Rework on Tiger Lake UP3 RVP for TSN AIC Phase 2

Document Number: 618525, Revision 1.05

Rework title	Rework on Tiger Lake UP3 RVP to enable MDC & MDIO signal
Rework #	WA-01: Workaround Rework
Change log #	WW51p2Y19 - Initial release
Description	Workaround to enable MDC and MDIO for Tiger Lake UP3 design for compatibility with TSN AIC Ph2
Rework Implementation Impact	SMBus on PCIe connector will be replaced by MDC and MDIO signals
Reworks involved	Resistors
Applicable to (affected skus)	J91106-101 TGL U DDR4 SODIMM ERB
Contact for details	Intel representative

Layout Snapshot – Top Side

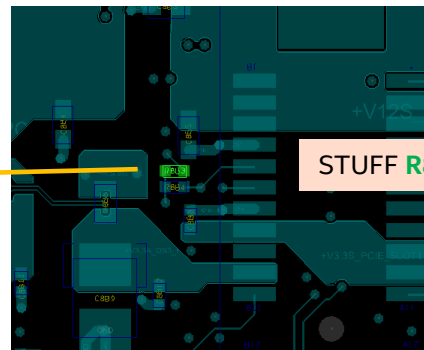
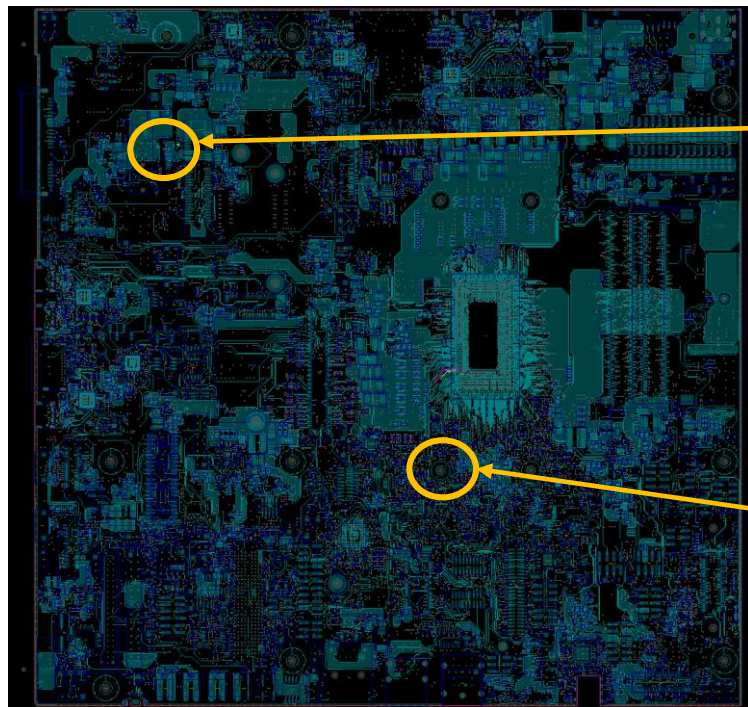
STUFF **R8B3** with A93549-001

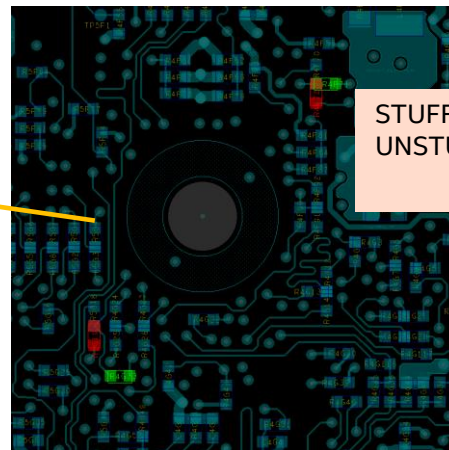
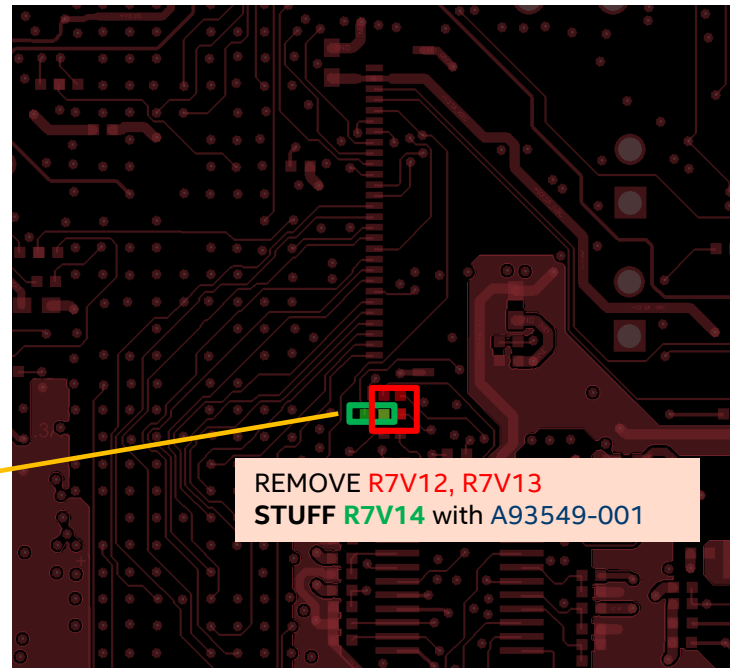
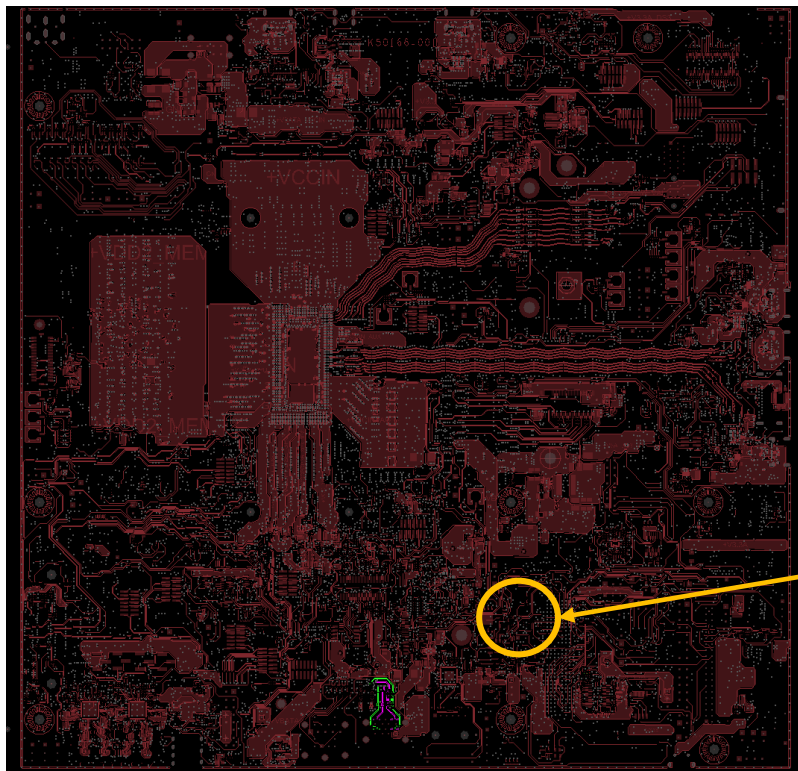
STUFF **R4G33** , **R4F71** with A93549-001
UNSTUFF **R5G19** , **R4F72**
